DEPARTMENT OF THE ARMY
HEADQUARTERS, U.S. ARMY AIR DEFENSE ARTILLERY CENTER AND FORT BLISS
1733 PLEASANTON ROAD
FORT BLISS, TEXAS 79916-6816

January 30, 1997

RE: Request for Class I Permit Modification for
US Army Air Defense Artillery Center
Fort Bliss Open Detonation Operational Permit
EPA ID No. NM 4213720101-01

FIGURE 2-1
 U.S. ARMY
 CORPS OF ENGINEERS
 COMPLIANCE SAMPLING
 SAMPLE STATION MAP
 FORT BLISS, TEXAS

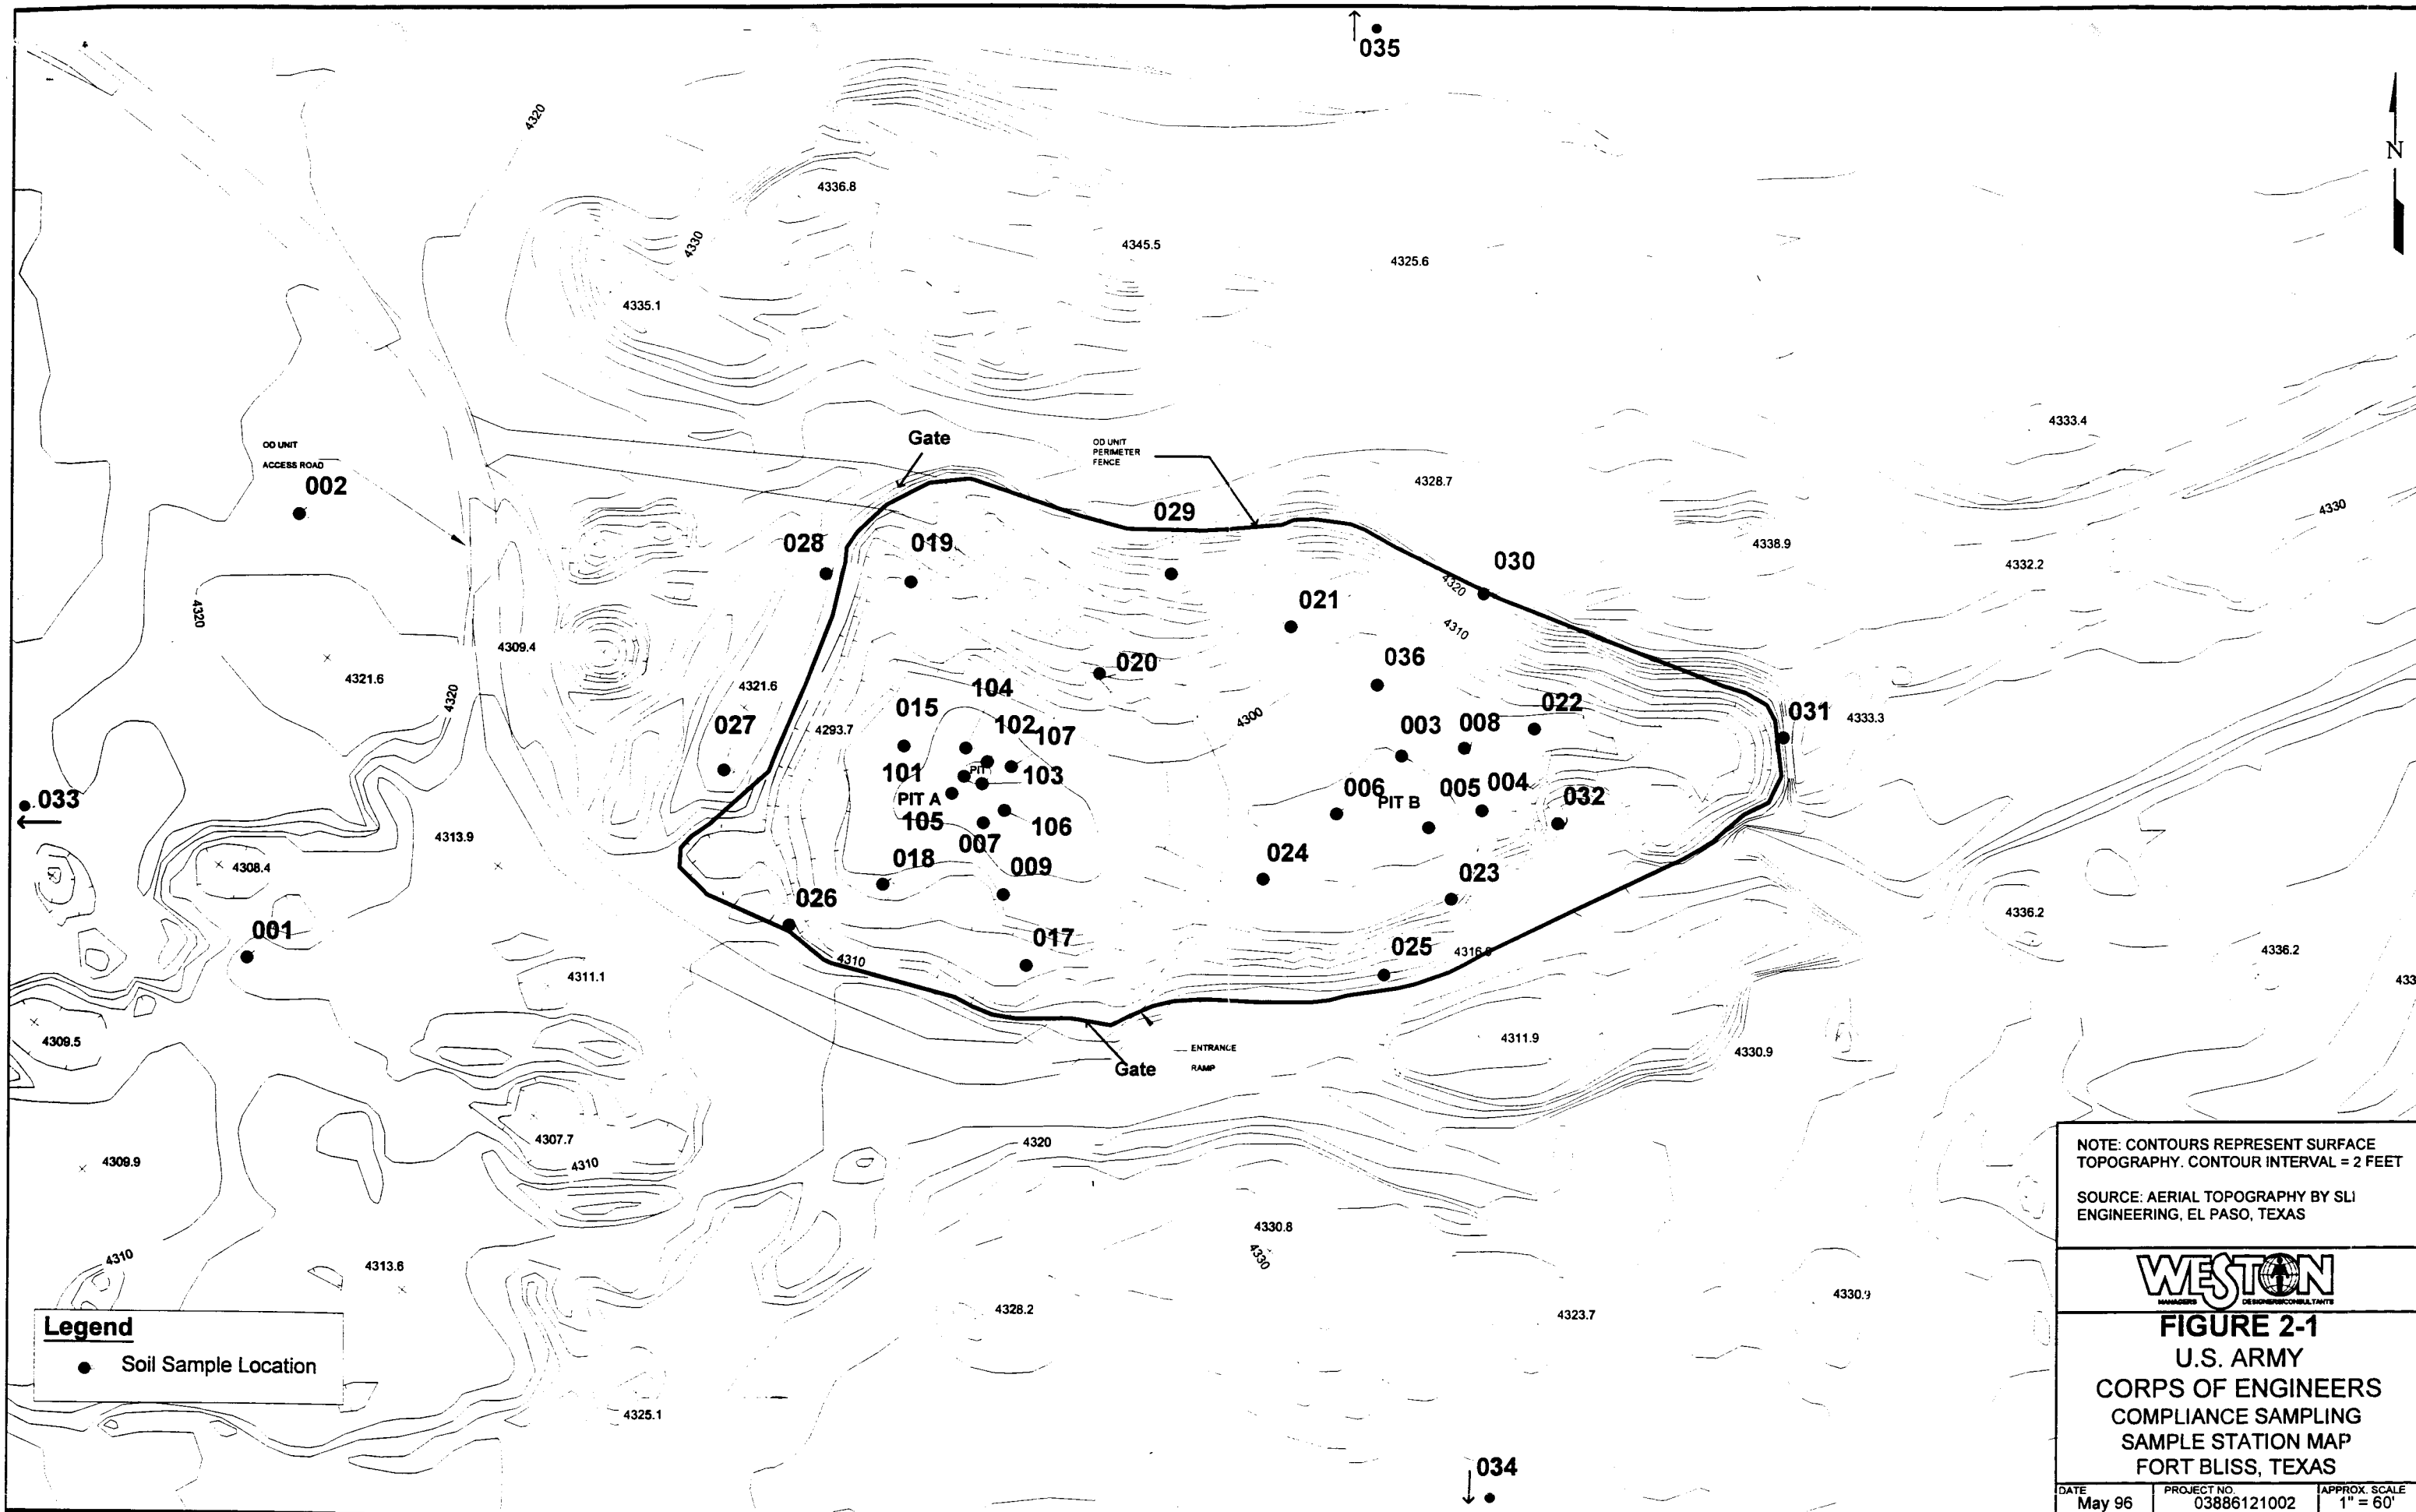
Three sampling events have been conducted to date at the OD Unit in which individual blast pits, the interior of the OD Unit, the OD Unit perimeter, background, and subsurface soil conditions have been investigated (see tables 1 & 2 and figure 2-1). A few of the locations illustrated on Figure 2-1 have been adjusted during the three events to allow for a complete assessment of the OD Unit. However, the locations illustrated in Figure 2-1 are generally representative of those utilized during all of the sampling events.

Permit Attachment J, Pages 14 and 16, Sampling Methods, 1st - 3rd Bullets. These areas require characterization of each of the OD pits in the excavation (Unit). This sampling approach applied to historical operational practices where there was a series of OD pits on the western side of the excavation and a series of pits on the eastern side of the excavation. As shown on Figure 2-1, each of these areas are referred to as Pit A and Pit B. According to the Fort Bliss 41st Explosives Ordinance Detachment, who operates the OD Unit, they have not conducted OD activities on the eastern side of the excavation in several years. The OD activities are currently conducted in the western portion (Pit A) of the excavation and the blast pits in the eastern portion of the excavation have been filled as a result of recent grading to control vegetation. Therefore, it is requested that the discreet pit sampling associated with the eastern OD pit be discontinued and assessment be conducted by repositioning the random samples that are required in the 5th bullet of the respective areas in the Permit. This would eliminate 8 samples from future sampling events.

Permit Attachment J, Page 16, first paragraph. These areas of the Permit require that soil samples be collected to a depth of 50 feet approximately in the middle of the OD Unit. To date, three 50 foot soil borings have been completed across the OD Unit and soil samples have been collected from approximately 5 foot intervals to total depth. No evidence of groundwater nor vertical migration of constituents of concern has been identified in any of the three soil borings completed at the Unit. Therefore, it is requested that sampling to a depth of 50 feet be discontinued.
